THE MARYLAND-NATIONAL CAPITAL PARK AND PLANNING COMMISSION

DATE: March 15, 2002
TO: Montgomery County Planning Board
VIA: Joe R. Davis, Chief *JRD*
Development Review/Division
FROM: Larry Ponsford AIA AICP *LPP*
Planning Department Staff
(301) 495-4576

REVIEW TYPE: Site Plan Review
APPLYING FOR: Approval of one single family detached dwelling
PROJECT NAME: Woodmont View
CASE #: 8-02026
REVIEW BASIS: Sec. 59-D-3, M. C. Zoning Ordinance

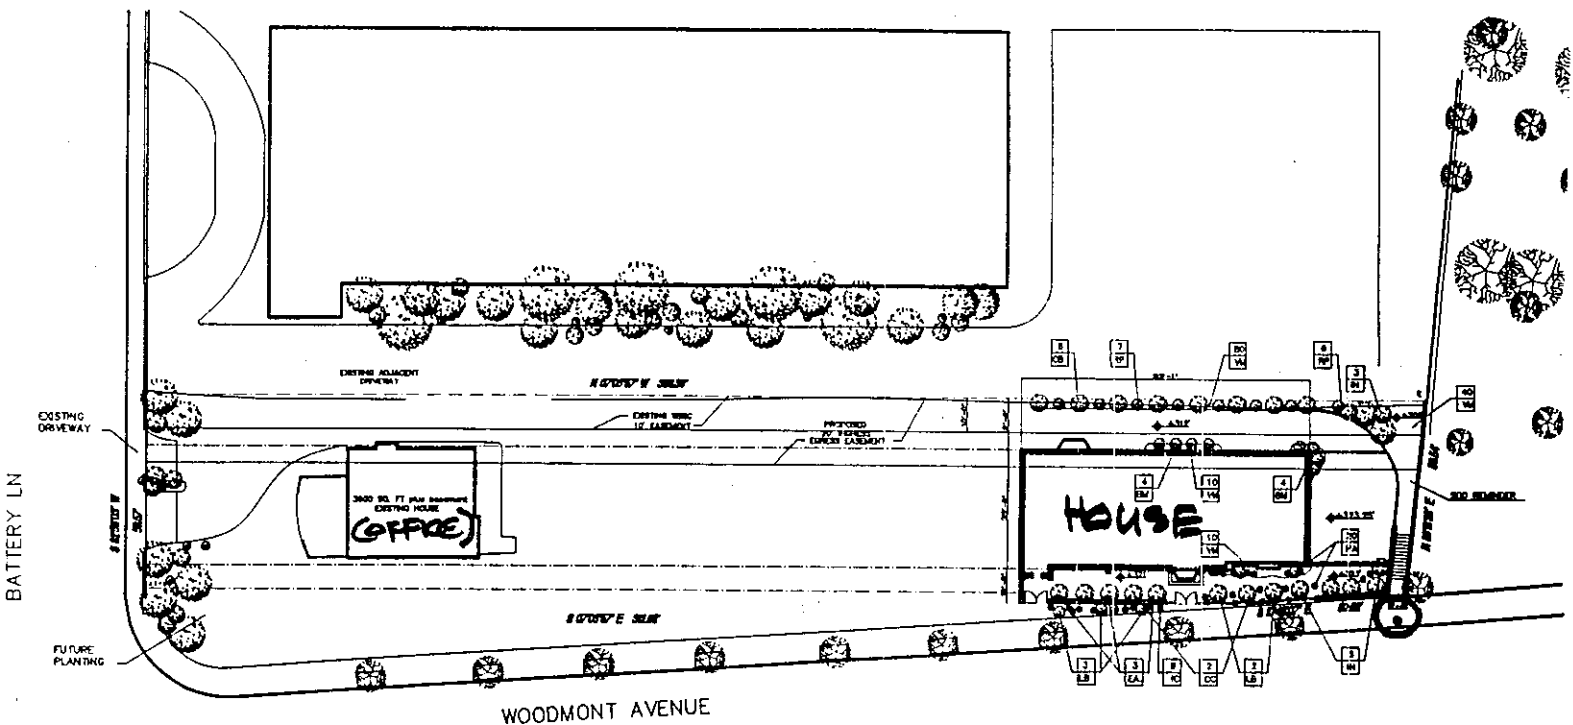
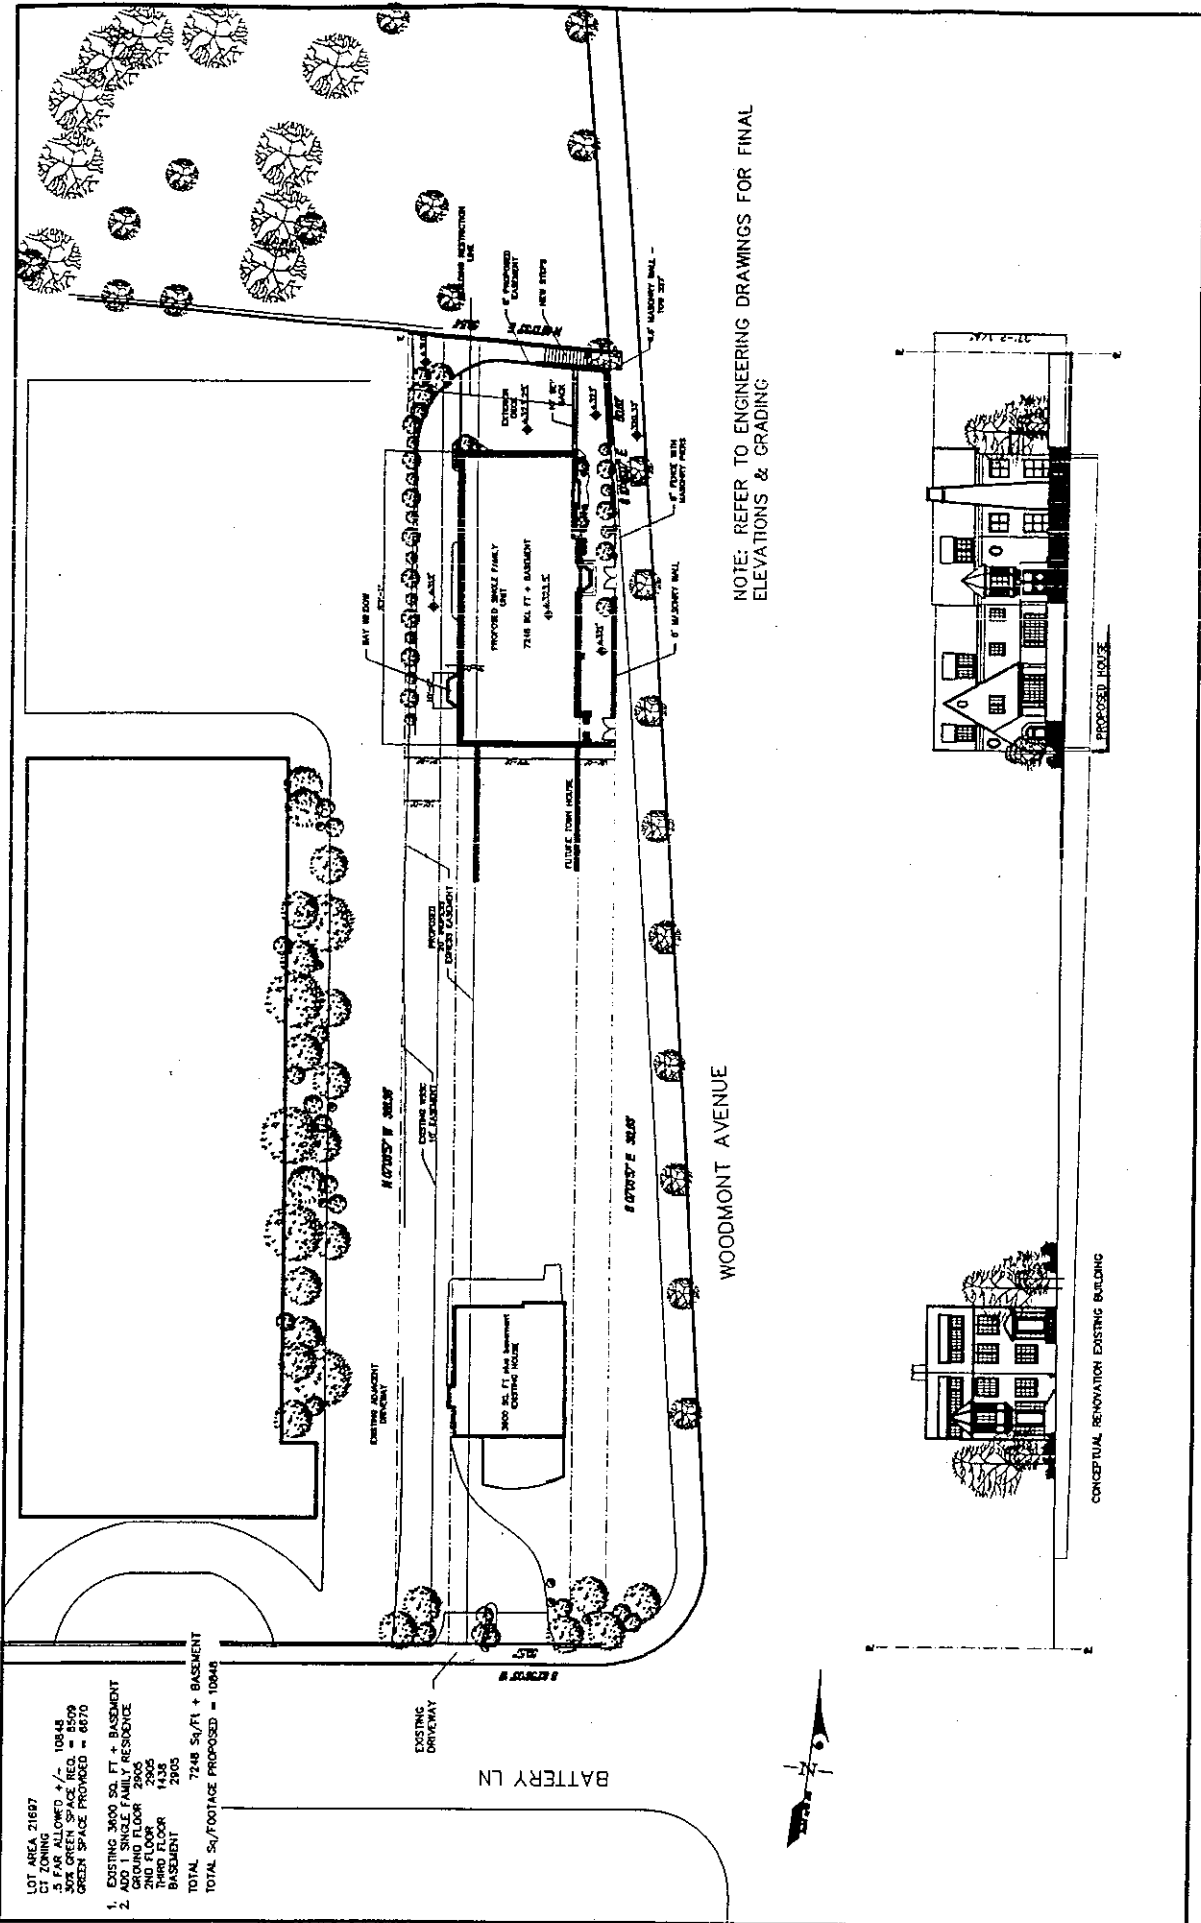
1. Standard Conditions dated October 10, 1995, Appendix A
2. Redesign stair to deck to not extend eastward beyond the face of the dwelling, to avoid building in the possible future Master Plan ROW on Woodmont
3. Move the pedestrian way stair in the easement along the north property line westward, to avoid building in the possible future Master Plan ROW on Woodmont
4. Provide Bethesda streetscape along Woodmont for the full frontage of the subject dwelling; add a street tree at the north property line along Woodmont, subject to MCDPWT approval.
5. Provide access easement along north property line, to contain pedestrian path and stair to Woodmont sidewalk
6. Dedicate 35 feet of ROW from Battery Lane centerline and truncation at intersection with Woodmont ROW.
7. Undergrounding of utilities to be postponed till future PD proposal is approved on remainder of lot.

Figure 6.1

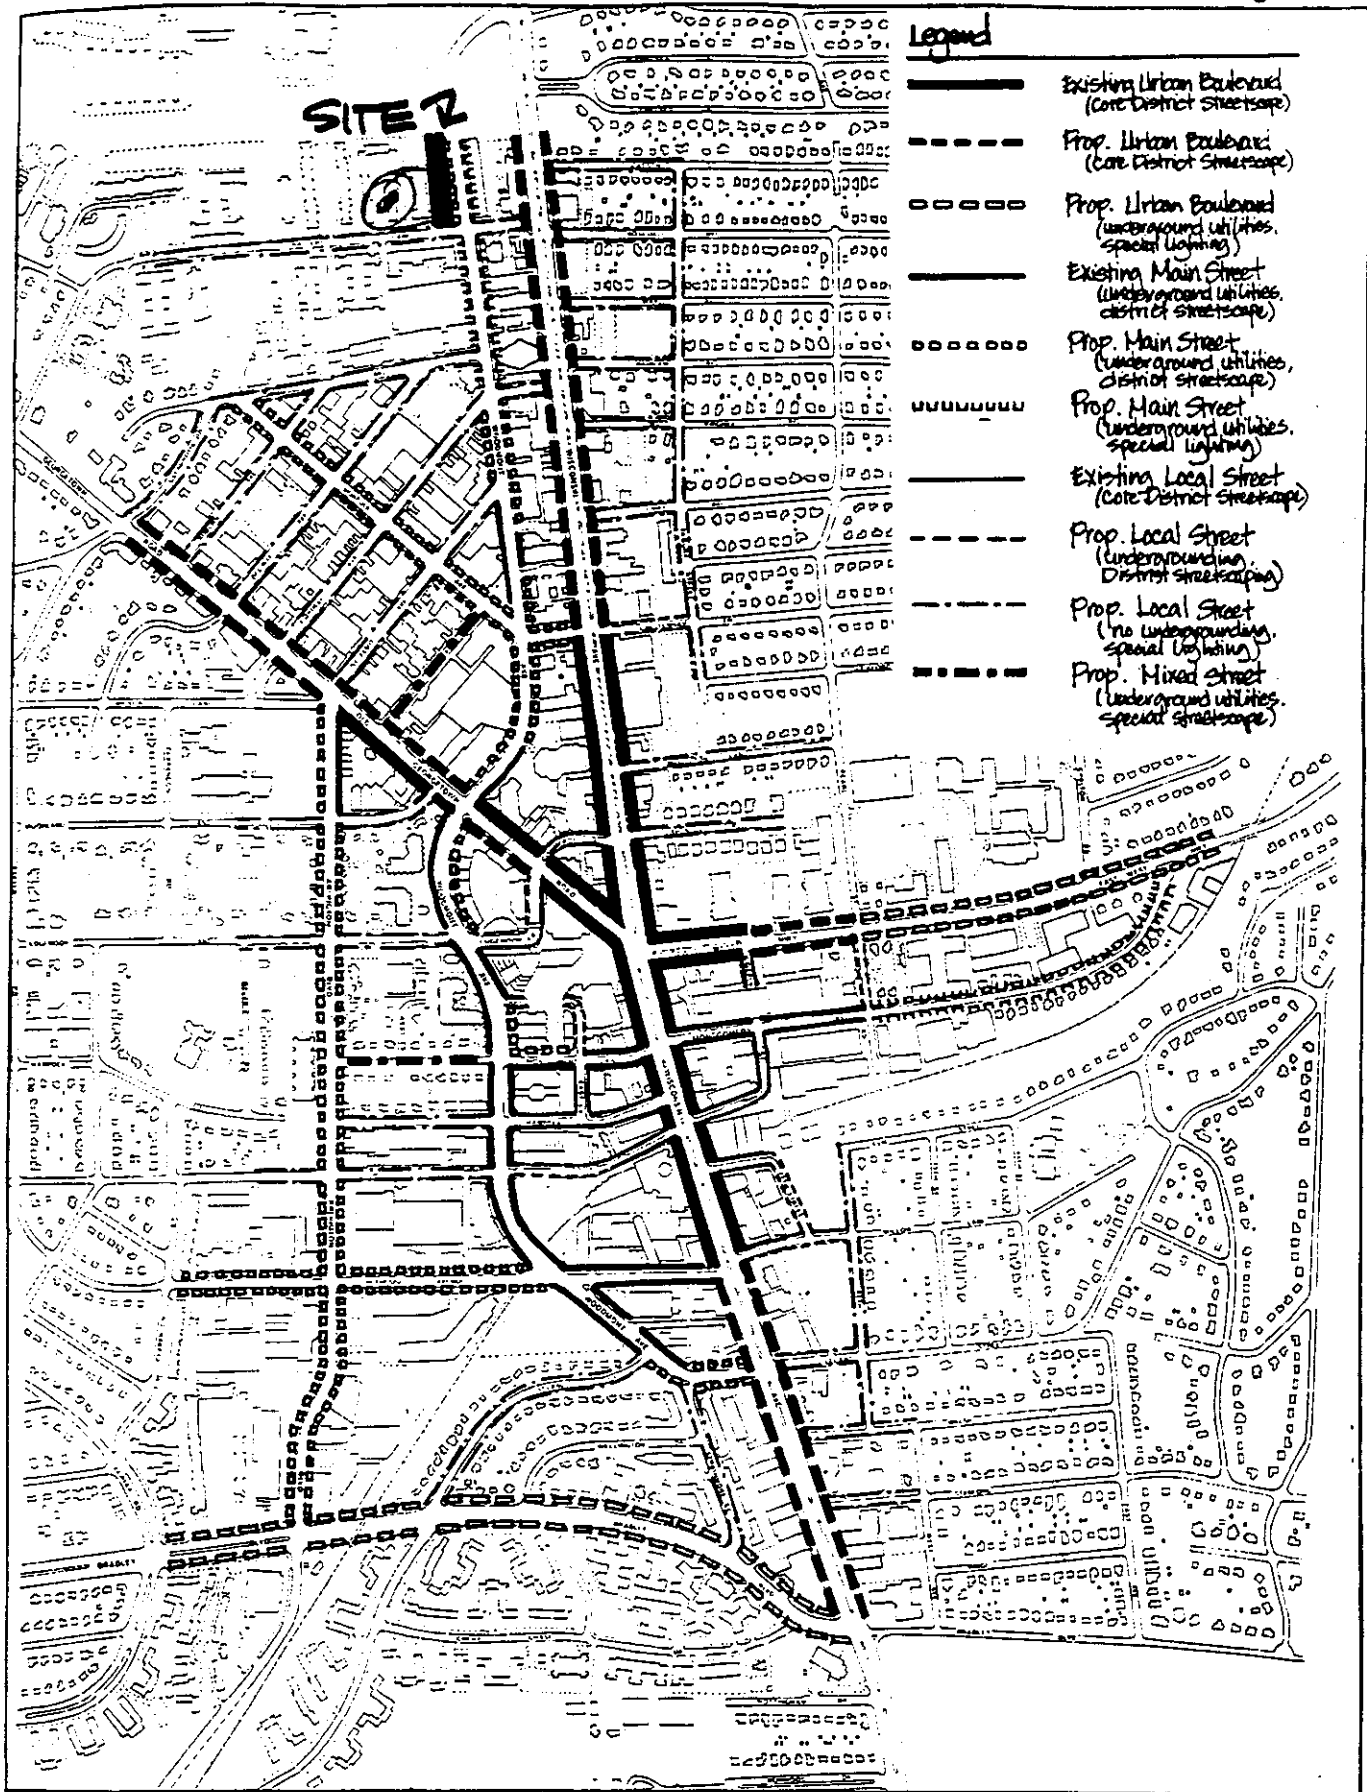
1. Arrange the buildings in a manner that acknowledges the site's gateway location for the Woodmont Triangle District and minimizes the "canyon effect" along Woodmont. This can be achieved by such measures as locating the bulk of the building perpendicular to the street, stepping back the upper floors, or architecturally expressing the two- or three-story base.
 2. Create a gateway to the Woodmont Triangle by providing flowering trees along the eastern edge of the site.
 3. Provide parking in the rear or below grade to minimize impact on the pedestrian environment.
- The proposal features a two-three story house, and a future row of townhouses is anticipated by the same owner; this is in conformance with the guideline for a low building along Woodmont. The street trees will be perpetuated per the Master Plan. The parking is on the level below the Woodmont sidewalk.
